Technical Service BULLETIN

REAR AXLE SEAL DESIGN CHANGE

'01 – '02 Sequoia, '95 – '02 Tacoma &
'00 – '02 Tundra

DL002-03

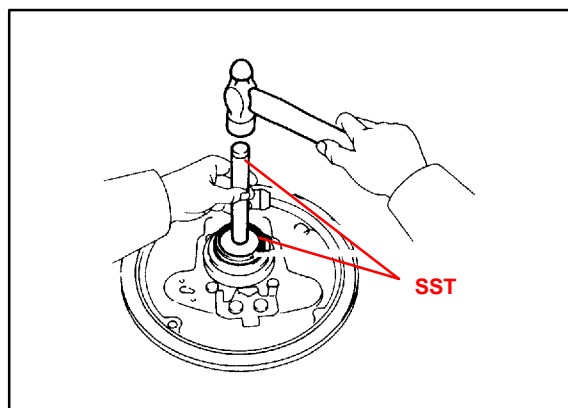
**Identification
Procedure**

The design of the rear axle seal has been changed from a flat face to an angled face for part number 90310-50006 and part number 90310-56002.
